# CITY OF SAN ANTONIO

Re: Mission Park Stone Oak

POADP # 676

The City Staff Development Review Committee has reviewed Mission Park Stone Oak Subdivision Preliminary Overall Area Development Plan # 676. Please find enclosed a signed copy for your files. Although your plan was accepted, please note the following:

MISSION PARK STONE OAK			
POADP			
DRAWN BY: WTF	FILE: 96005POA	APPROVED BY: NF	
SCALE: 1" = 200'	DATE: DECEMBER 1999	SHEET 1 OF 1	
REV. NO.	JOB NO. 96005

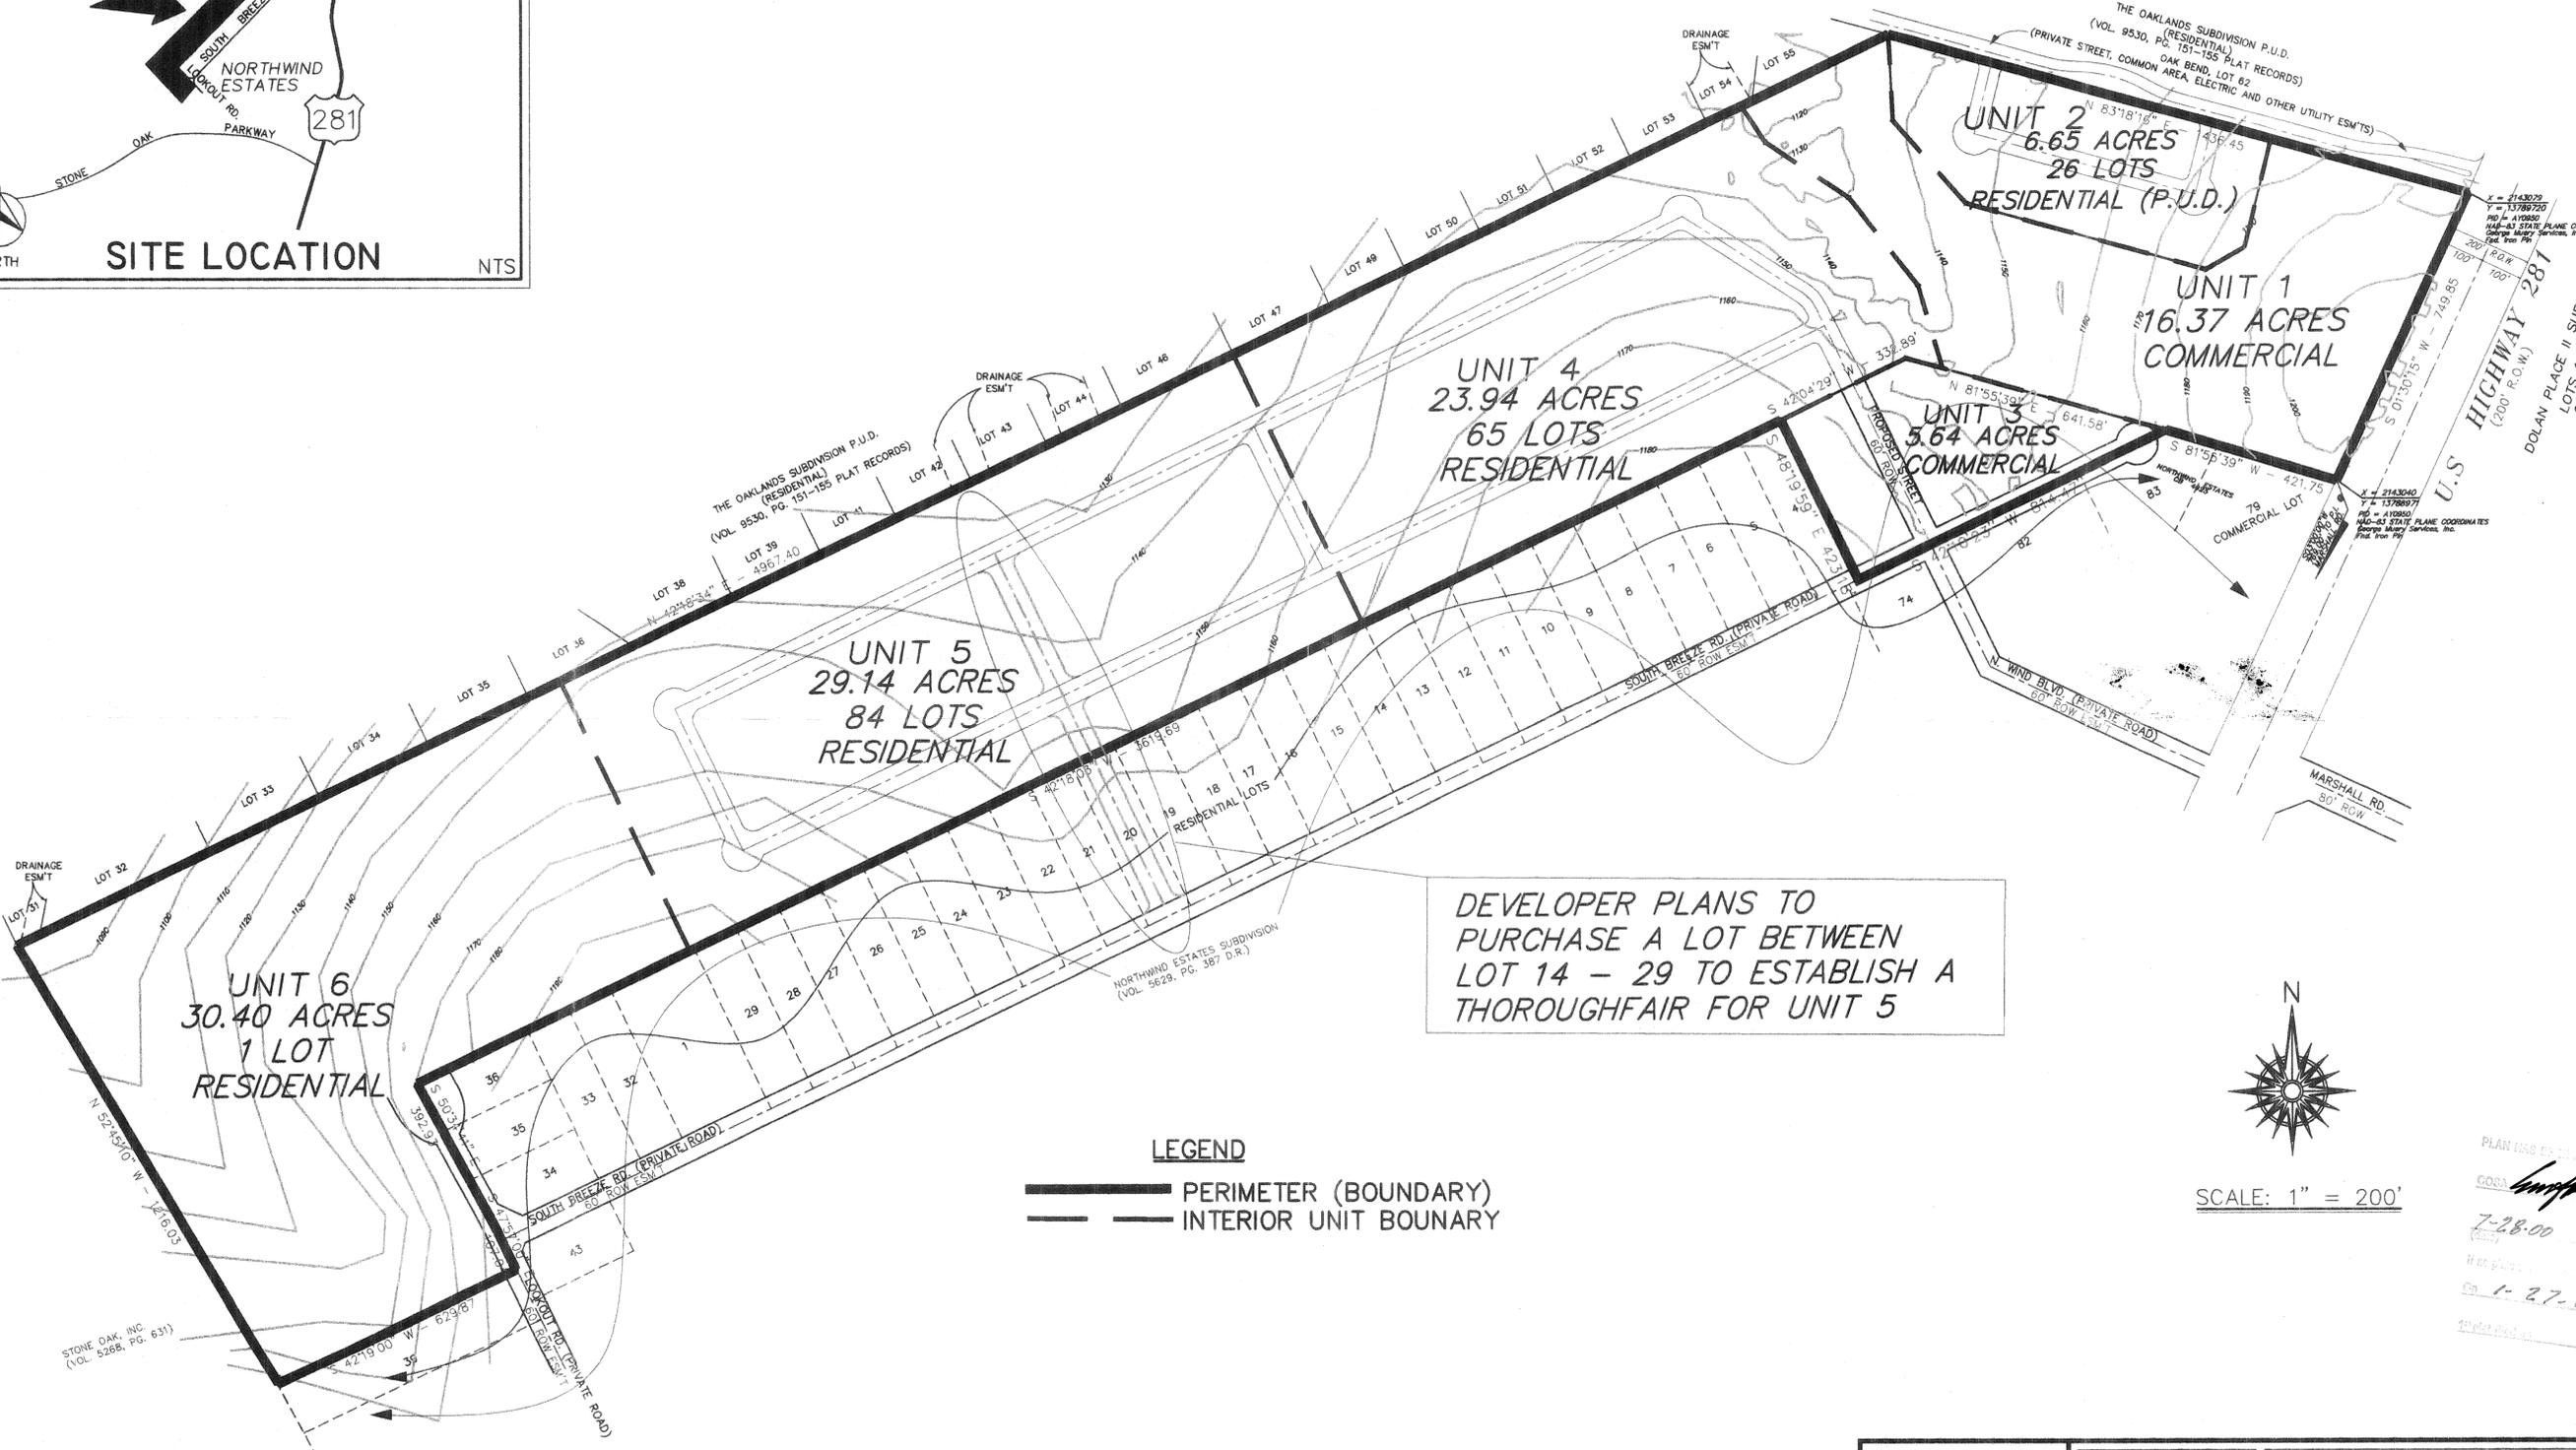
- Based on the topography, a Flood Plain Study and drainage review will probably be required during the platting process. Bexar County Public Works may require base flood elevations at the plat level.

- In consideration of public safety and convenience, excessive grades by reason of topography should be avoided in street layouts and arrangements.
- This development will probably need to conform to requirements associated with development over the Edwards Aquifer. For additional information about these requirements you can contact SAWS at 704-7305.

- Access and R.O.W. issues along State facilities will need to be resolved with the Texas Department of Transportation (TXDOT). For information about these requirements you can contact TXDOT at 615-5814.

- This development will need to comply with tree preservation ordinance #85262. For information about these requirements you can contact Building Inspections at 207-7102.

- It will be expected that you will plat all of the property depicted in your POADP, to include: floodpains, drainage areas and open space.

- I would encourage you to work closely with the school district, so that they can plan accordingly.
